Well Name: MEAN GREEN 22 FED COM	Well Location: T26S / R34E / SEC 22 / SESE / 32.0219314 / -103.4499182	County or Parish/State: LEA / NM
Well Number: 1H	Type of Well: OIL WELL	Allottee or Tribe Name:
Lease Number: NMNM94118	Unit or CA Name: MEAN GREEN 22 FED COM 1H	Unit or CA Number: NMNM134697
US Well Number: 3002541434	Operator: DEVON ENERGY PRODUCTION COMPANY LP

## Notice of Intent

Type of Action: Plug and Abandonment

## WELLBORE DIAGRAM - PROPOSED

## WELLBORE DIAGRAM - CURRENT

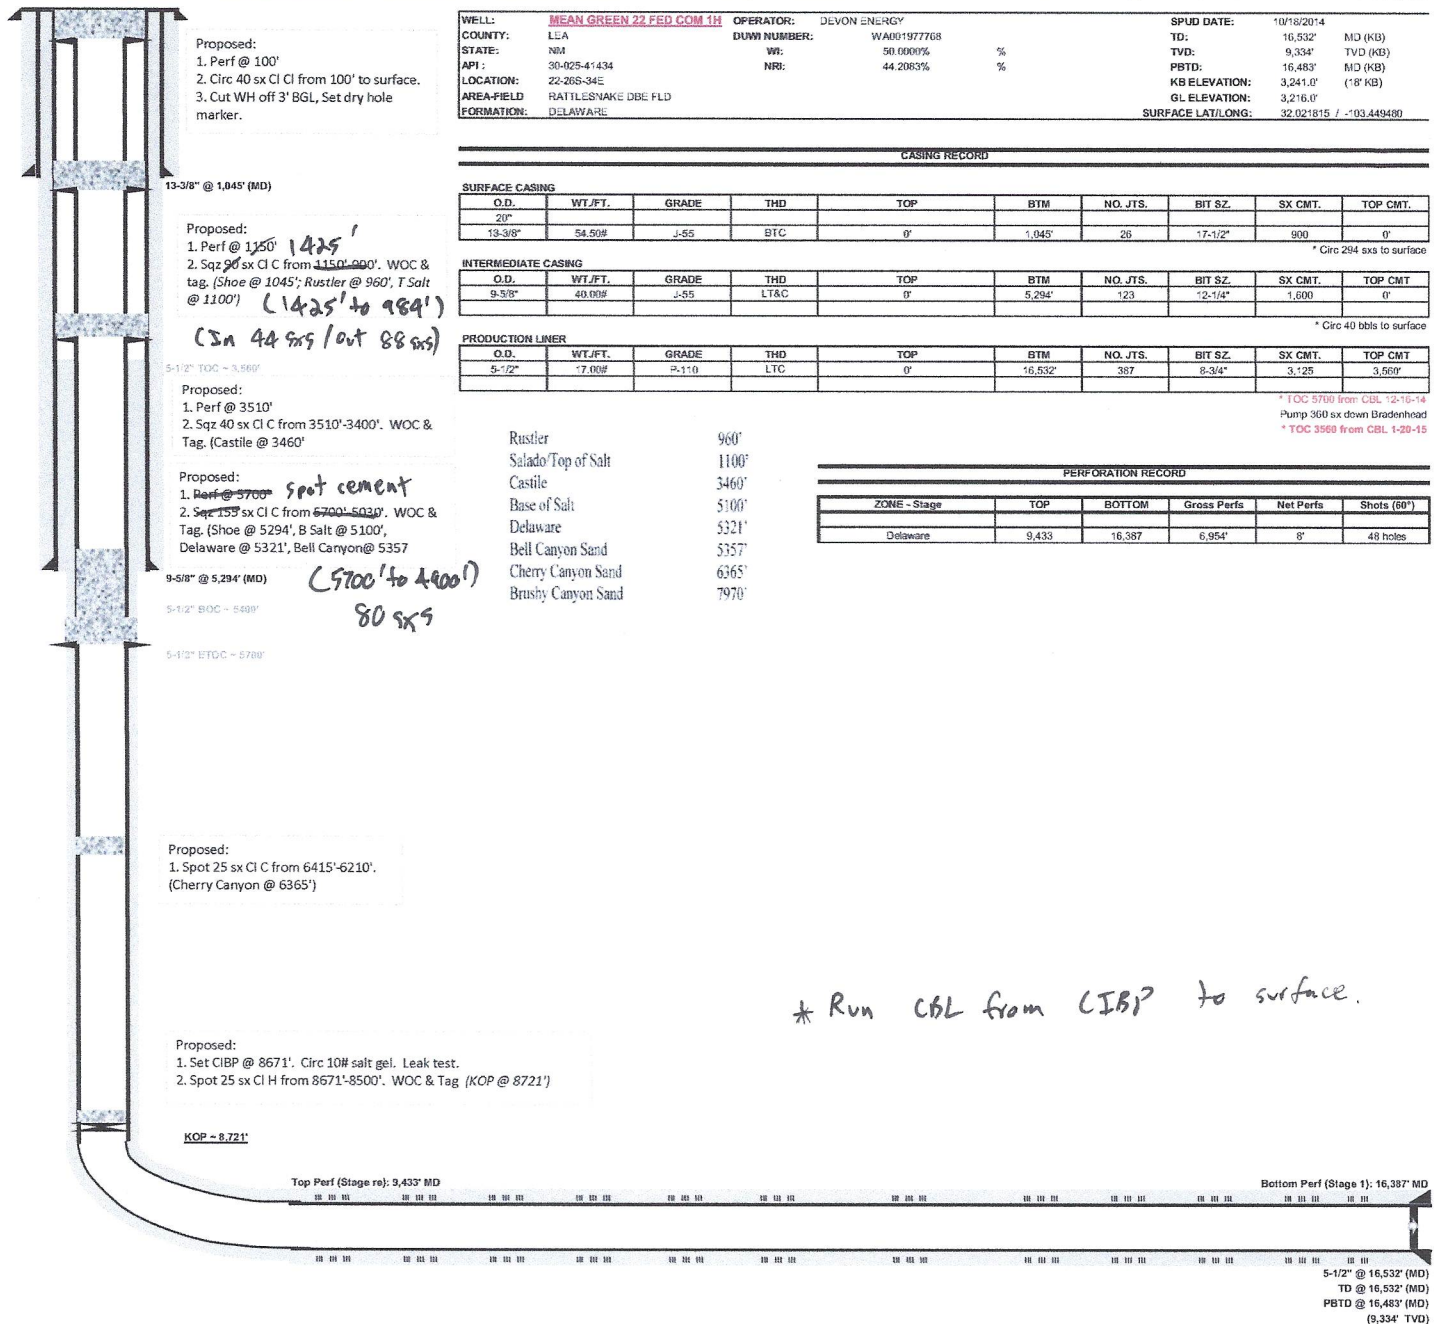
5. Perf @ 5700'. Sqz 155 sx CI C from 5700'-5030'. WOC &amp; Tag. (T. Delaware @ 5321'; Shoe @ 5294'; B. Salt @ 5100'; Bell Canyon @ 5357') 80 SXS (5700' to 4900')

6. Perf @ 3510'. Sqz 40 sx CI C from 3510'-3400'. WOC & Tag. (Castile @ 3460') ~~Set cement if no injection~~ 1425' to 984' (In 44 SXS/4188 SXS)

\* Run CBL from CIBP to surface.

Plug Type	Top	Bottom	Length	Tag	Sacks	Cement Class	Notes
<b>Surface Plug</b>	0.00	100.00	100.00	Tag/Verify	<b>30.00</b>	<b>C</b>	<b>Perf and squeeze from 100' to surface. Verify at surface. (In 10 sxs/Out 20 sxs)</b>
<b>13.375 inch- Shoe Plug</b>	984.55	1095.00	110.45	Tag/Verify			
<b>Top of Salt @ 1375</b>	1311.25	1425.00	113.75	Tag/Verify	132.00	C	Perf and squeeze from 1425' to 984'. WOC and Tag. (In 44 sxs/Out 88 sxs)
<b>Base of Salt @ 5001</b>	4900.99	5051.00	150.01	Tag/Verify			
<b>9.625 inch- Shoe Plug</b>	5191.06	5344.00	152.94	Tag/Verify			
<b>Delaware @ 5332</b>	5228.68	5382.00	153.32	If solid base no need to Tag (CIBP present and/or Mechanical Integrity Test), If Perf & Sqz then Tag, Leak Test all CIBP if no Open Perforations	80.00	C	Spot cement from 5700' to 4900'. WOC and Tag
<b>KOP @ 8645</b>	8508.55	8695.00	186.45	If solid			
<b>CIBP Plug</b>	8636.00	8671.00	35.00	If solid base no need to Tag (CIBP present and/or Mechanical Integrity Test), If Perf & Sqz then Tag, Leak Test all CIBP if no Open Perforations	25.00	H	Set CIBP at 8671 feet. Leak test CIBP. Spot 25 sxs on top.
